SMITH PLACE SUBDIVISION,
RESUBDIVISION OF LOTS 4 & 5

APPLICATION NUMBER 9 DATE March 19, 2009

REQUEST Subdivision

DETAIL SITE PLAN

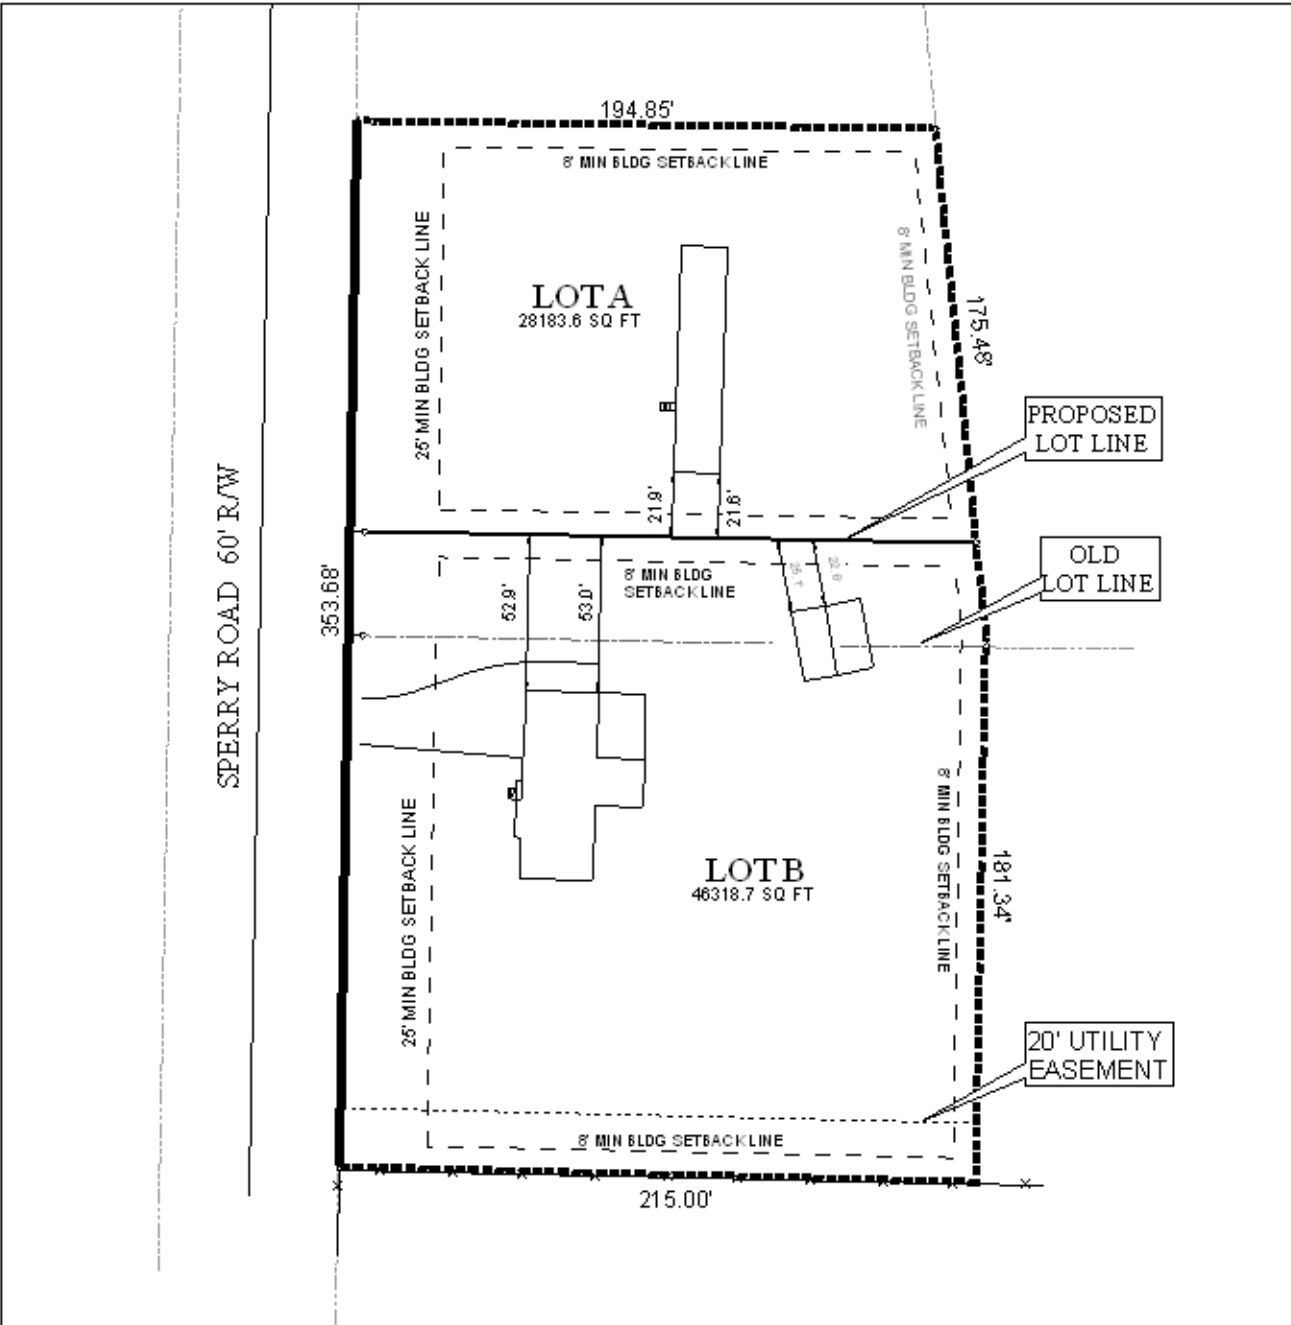
The plat illustrates the proposed 1.7± acre, 2 lot subdivision, which is located on the East side of Sperry Road, 260'± South of Old Pascagoula Road – within the planning jurisdiction. The applicant states that the site is served by public water and sewer facilities.

The purpose of this application is to move an interior lot line between two legal lots record.

The site fronts Sperry Road, a minor street with sufficient right-of-way. No dedication is required.

As proposed, Lots A and B have approximately 138' and 215' of frontage along Sperry Road, respectively. As a means of access management, a note should be placed on the final plat stating that each lot is limited to one curb cut to Sperry Road, with the size, location, and design to be approved by County Engineering and in conformance with AASHTO standards.

The site is located in the county. Therefore, a note should be placed on the final plat stating that any lots developed commercially and adjoin residentially developed property must provide a buffer, in compliance with Section V.A.7. of the Subdivision Regulations.

While the site is located in the county, compliance with the City of Mobile storm water and flood control ordinances will be required. A letter from a licensed engineer certifying compliance with the City's storm water and flood control ordinances should be submitted to the Mobile County Engineering Department and the Planning Section of Mobile Urban Development prior to the issuance of any permits.

Based on the preceding, the plat meets the minimum requirements of the Subdivision Regulations and is recommended for Tentative Approval, subject to the following conditions:

- 1) placement of a note stating that each lot is limited to one curb cut to Sperry Road, with the size, location, and design to be approved by County Engineering and conform to AASHTO standards;

- 2) placement of a note on the plat / site plan stating that the site must be developed in compliance with all local, state and Federal regulations regarding endangered, threatened or otherwise protected species;

- 3) placement of a note on the final plat stating that any lots developed commercially and adjoin residentially developed property shall provide a buffer in compliance with Section V.A.7. of the Subdivision Regulations; and

- 4) submission of a letter from a licensed engineer certifying compliance with the City of Mobile's storm water and flood control ordinances to the Mobile County Engineering department and the Planning Section of Mobile Urban Development prior to issuance of any permits.
